Access Compliance Report

Public Rights-of-Way

(Curb Ramps)

Intersection ID: 49789	Main Street: BARLEY_LN	Cross Street: GRASS_DR	Location:	N
ADA ID: 150CC58BF0D4	Ramp Type: Perp	Initial Pass/Fail: Pass	Overall Compliance: No	Severity Score: 5.25
Codes/Mitigation Info/Possible Solution		Field Measurements/Component Compliance

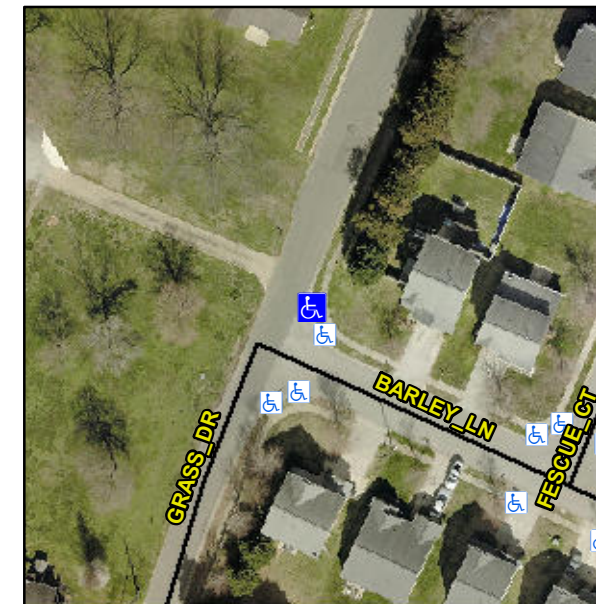
**Not Found, R304.5.3, R304.2.2-Perp,
R304.3.2-Para, R304.5.4**

Compliance	Description	Data	Compliance	Description	Data
N/A	Ramp Length (in)	47.5	Yes	Ramp Slope (%)	6.5
Yes	Ramp Width (in)	48.5	No	Ramp XSlope (%)	2.5
N/A	Flare Type LT	Sloped	N/A	Flare Type RT	N/A
N/A	Flare Slope LT (%)	5.3	Yes	Flare Slope RT (%)	1.4
N/A	Flare Traversable LT?	Yes	N/A	Flare Traversable RT?	Yes
Yes	Landing Length (in)	48.0	Yes	DWS Provided?	Yes
Yes	Landing Width (in)	48.5	Yes	DWS Contrast?	Yes
No	Landing Slope (%)	3.2	Yes	DWS Length (in)	24.5
No	Landing X Slope (%)	3.4	Yes	DWS Full Width?	Yes
N/A	Landing Curb? (Y/N)	No	Yes	DWS Offset (in)	0.0
N/A	Shared Landing?	No			
Yes	Gutter Ponding?	No	No	Gutter Slope (%)	7.7
Yes	Gutter Lip Ht (in)	0.0	No	Gutter X Slope (%)	2.3
N/A	Painted X Walk1?	No	N/A	Painted X Walk2?	N/A
	X Walk 1 Direction	To W		X Walk 2 Direction	N/A
N/A	X Walk 1 Width (in)	N/A	N/A	X Walk 2 Width (in)	N/A
	X Walk 1 Slope (%)	2.1		X Walk 2 Slope (%)	N/A
	X Walk 1 X Slope (%)	1.6		X Walk 2 X Slope (%)	N/A

N/A	Ramp inside XWalk1?	N/A	N/A	Ramp inside XWalk2?	N/A
	Road Slope (%)	N/A	N/A	Clear Space?	Yes
	Road X Slope (%)	N/A	N/A	Clear Space to XWalk (in)	N/A
Yes	Any Obstructions?	No	Yes	Storm Grate/Utility Hazard?	No
	Obstruction Type			Storm Grate/Utility Type	
		N/A			N/A
			Yes	Surface Condition? (G/P)	Good

**Remove & Replace Entire Ramp.
Remove & Replace Gutter.**
